Strathfield Independent Hearing and Assessment Panel Meeting

Thursday, 5 October 2017

SUBJECT: 19-23 SMALLWOOD AVENUE, HOMEBUSH
LOT 1 & 2 DP 312801 & LOT A 311140

DA NO. 2017/090

Figure 4: View of the southern elevation noting the extent of the proposed building height variation.

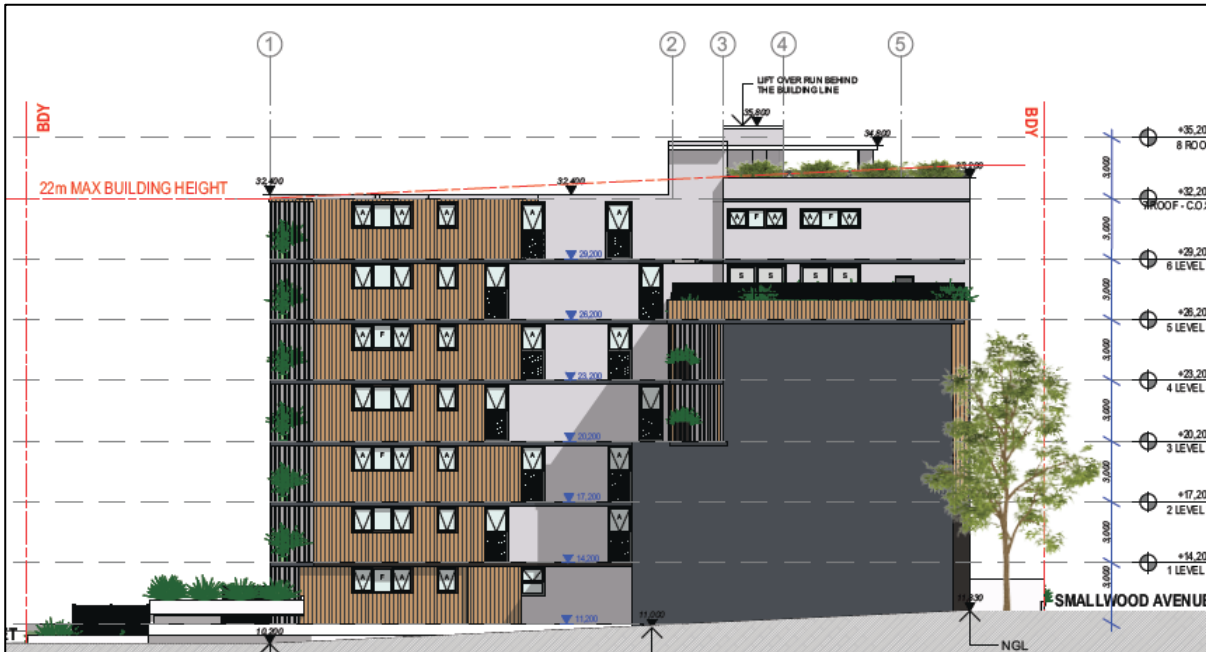
As demonstrated in the table above, the proposed development fails to comply with the maximum 22m building height under Clause 4.3 of the SLEP 2012. The area of non-compliance specifically relate to the shade structure, lift overrun and stair access (refer to Figure 4). As such, the proposed development extends 1.6m beyond the maximum permissible building height of 22m resulting in a departure of 7.27%.

In conclusion, the applicant’s written request to justify the contravention of the building height development standard is considered to be well founded in that the applicant has satisfactorily demonstrated that compliance with the standard is unnecessary or unreasonable in the circumstances of the case, and that there are sufficient environmental planning grounds to justify contravening the development standard.

Figure 5: Level 2 Floor Plan

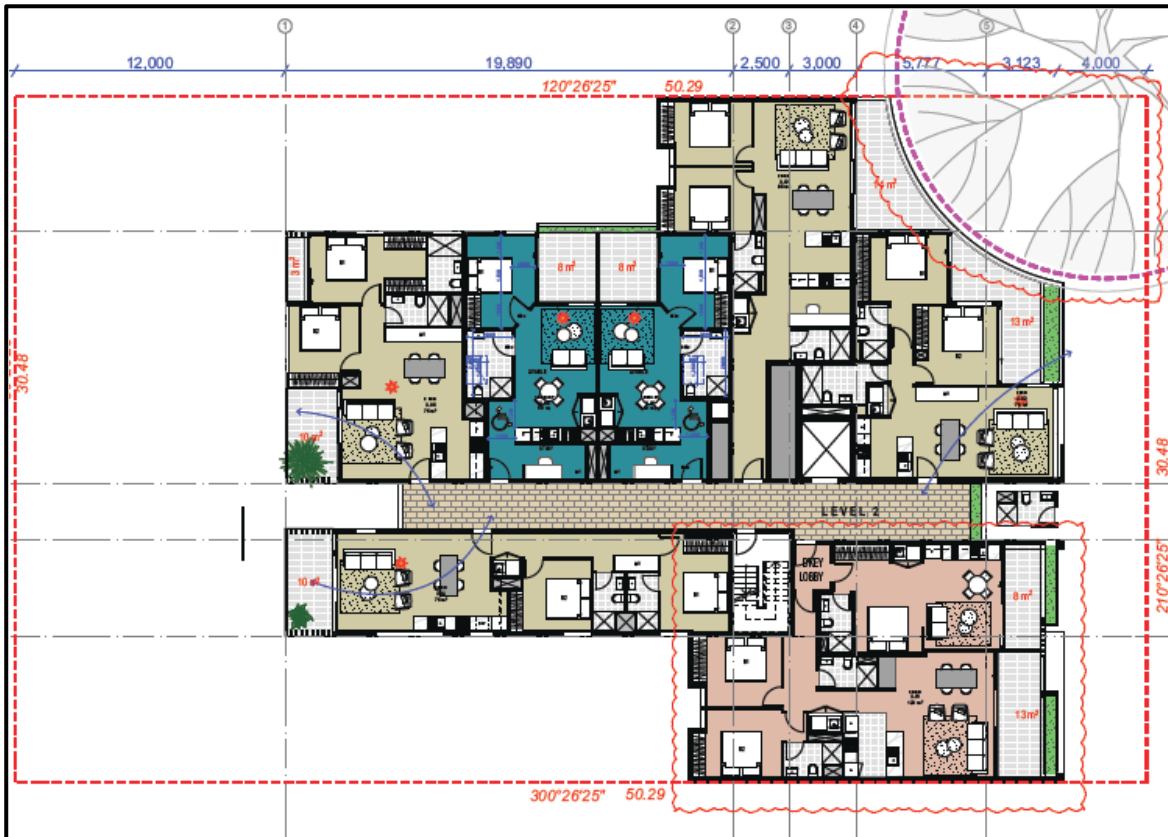
Section 3F of the ADG requires an appropriate level of building separation to be provided so as to minimise opportunities for overlooking between adjoining developments. The proposed development generally accords with the built form envisaged under DCP 20 through providing nil side setbacks to portions of both the northern and southern side boundaries of the site. Refer to Figure 5 below.

Of the portions which aren't provided with a nil side setback, 6.5m separation is provided to the southern side elevation of the building and 6m separation is provided to the northern side elevation of the building. It is appreciated that various windows are proposed to the southern elevation of the development within 6.5m of the boundary however, a blank wall is provided to the northern elevation of the approved development to the south which will not result in privacy concerns for southern adjoining residents. It is noted that there are discrepancies between the floor plans and elevation plans whereby a number of windows to the ground floor and first floor of the development are missing in the southern elevation plan. A condition of consent has been recommended to rectify this.

Date of Issue	22/09/2017	Drawn	TY	Approved	ZB
Scale	1:100				
Project Number	17018	Drawing Number	DA2001 D

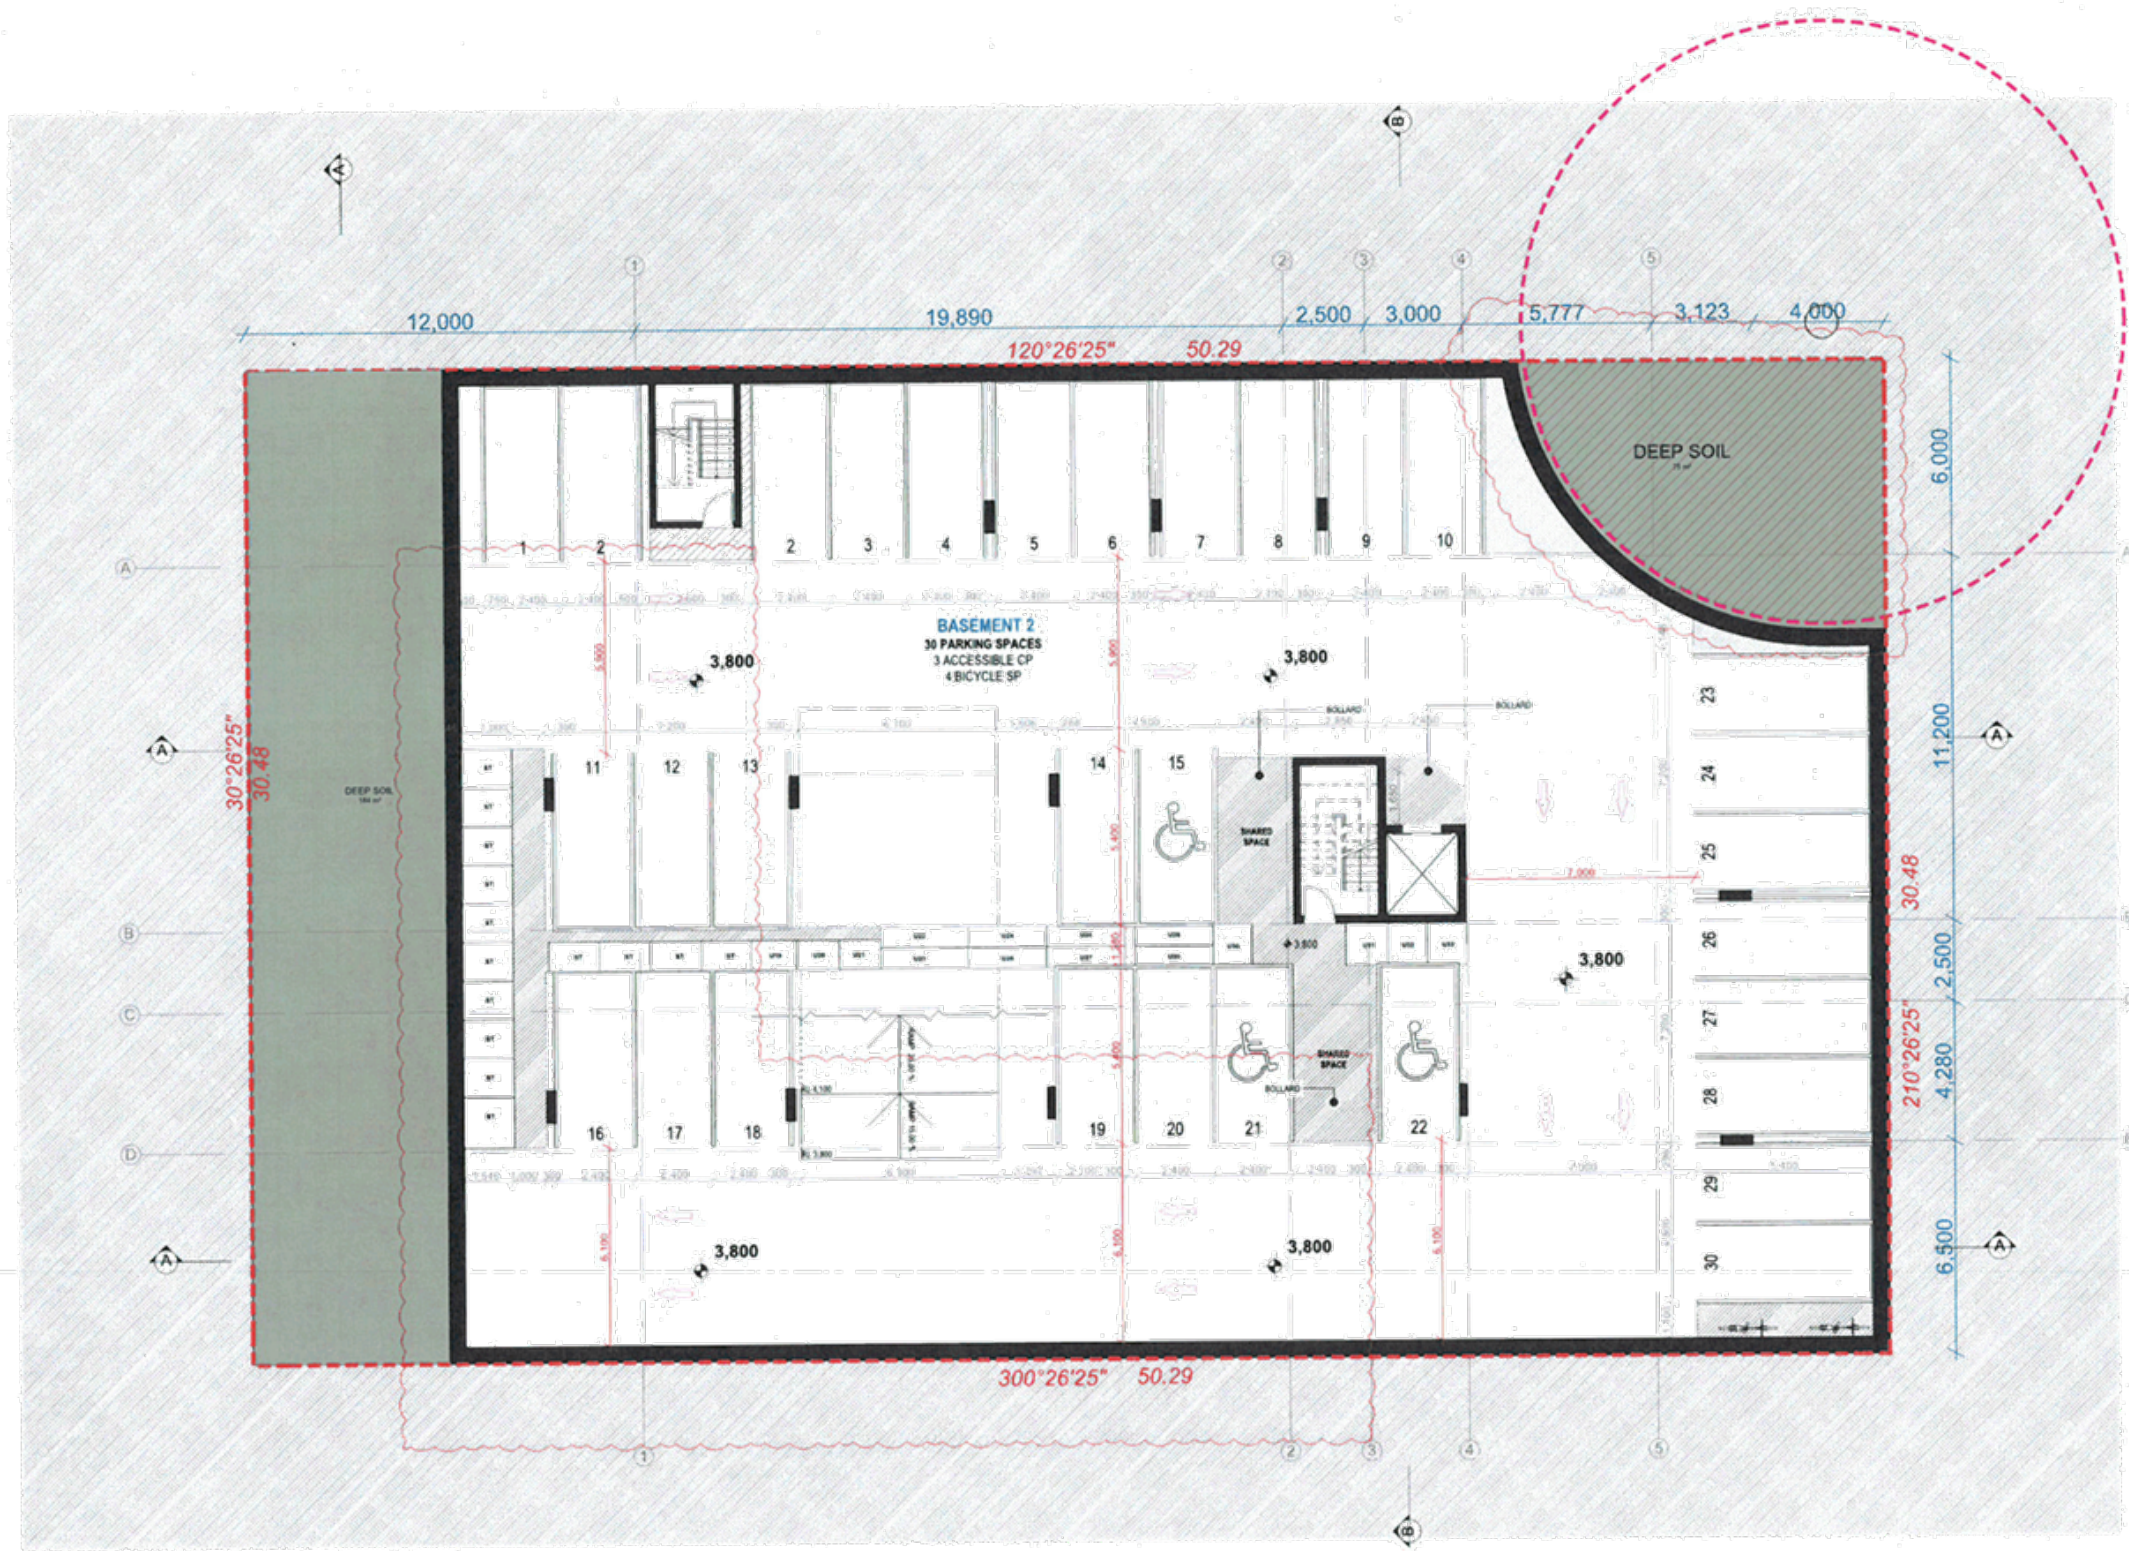
AMENDMENTS, ISSUE C
 NO ENCROACHMENT INTO TPZ
 VEHICAL ENTRY SWITCHED TO SMALLWOOD AVE FROM HUDSON ST

South Elevation

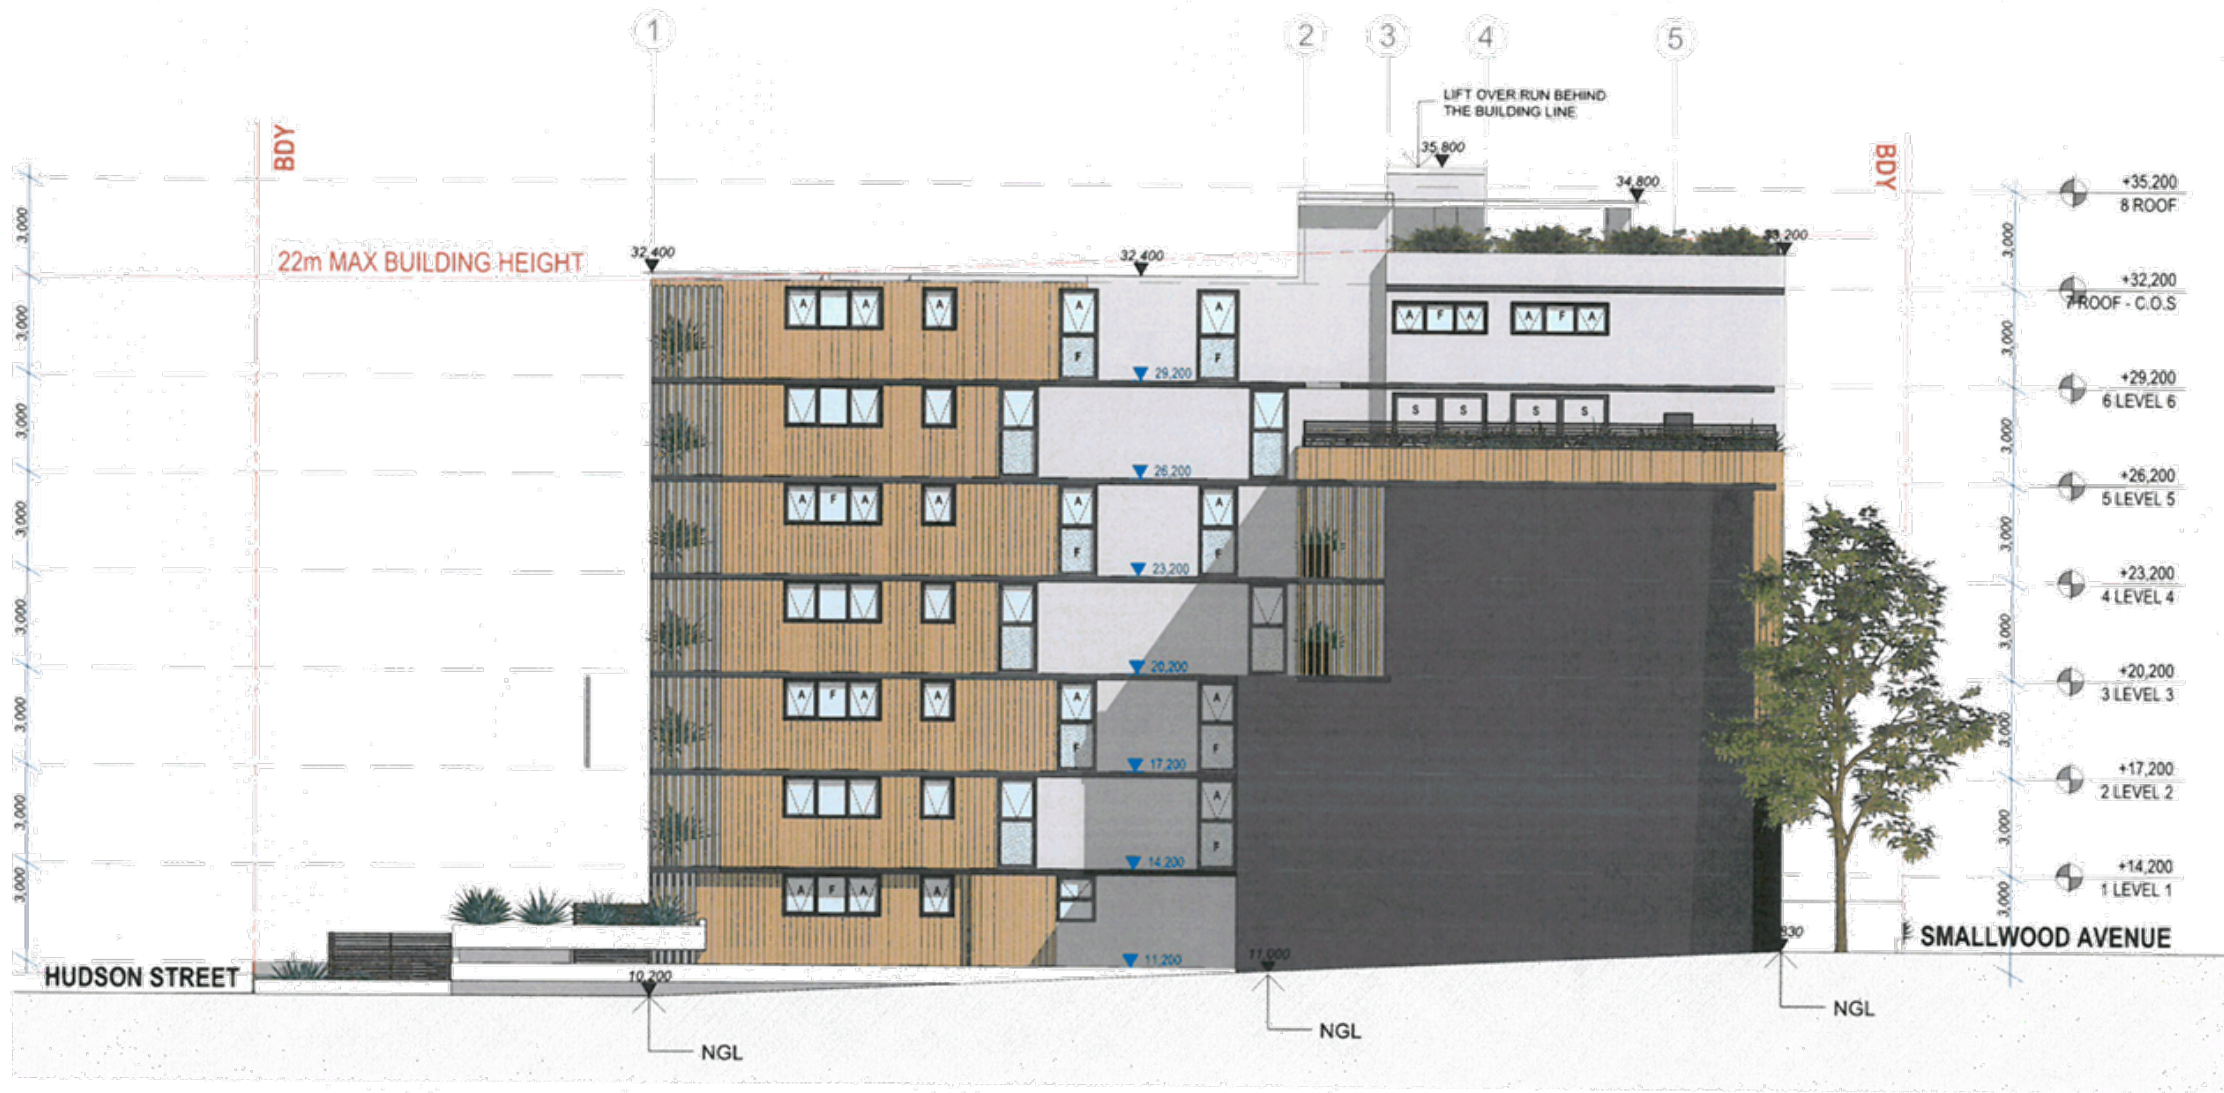
1. SOUTHERN ELEVATION PLAN (SC)

The southern elevation plan labelled "South Elevation Drawing No:DA3002, Issue D prepared by Urbanlink" shall be amended to reflect the additional windows proposed to the ground floor and first floor units of the development. Amended plans shall be prepared and submitted to an Accredited Certifier for approval **prior to the issue of a Construction Certificate.**

Figure 5: Proposed signage on windows of board room, training and office as viewed from Hillcrest Street.

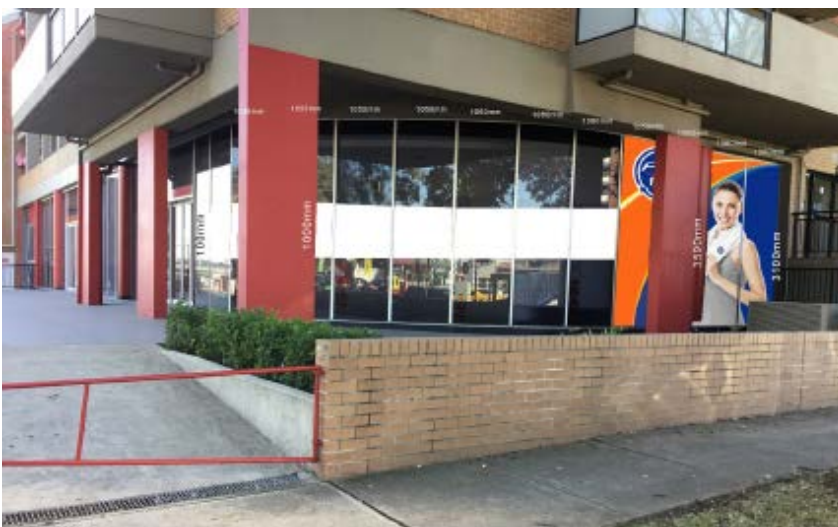
According to Section 4 of Part J 'Erection and Display of Advertising Signs and Structures' of the SDCPC 2005, window signs shall not cover more than 25% of the shop window. The proposed

Whilst the placement of some of the larger signage is warranted to provide privacy due to the nature of the room (office), the overall amount of signage is excessive and may not only distract passing motorists along Parramatta Road, is likely to visually detract from the aesthetic nature of what is predominantly a residential building. Specifically, the proposed white signage in Figure 3 is to be deleted, additionally the '24 hours' and '7 days' white and black signs shown in Figure 4 are not required as there is a sign directly above stating the same information, that the premises is open 24 hours 7 days a week. To encourage passive surveillance between the premises and the public domain a condition has been recommended for all of the signage to comprise of semi-transparent material and all remaining glass areas to be 100% clear with no window treatment. In addition to passive surveillance the condition will align the gym signage with similar gym facilities facing classified roads that are located within the Strathfield Local Government Area.
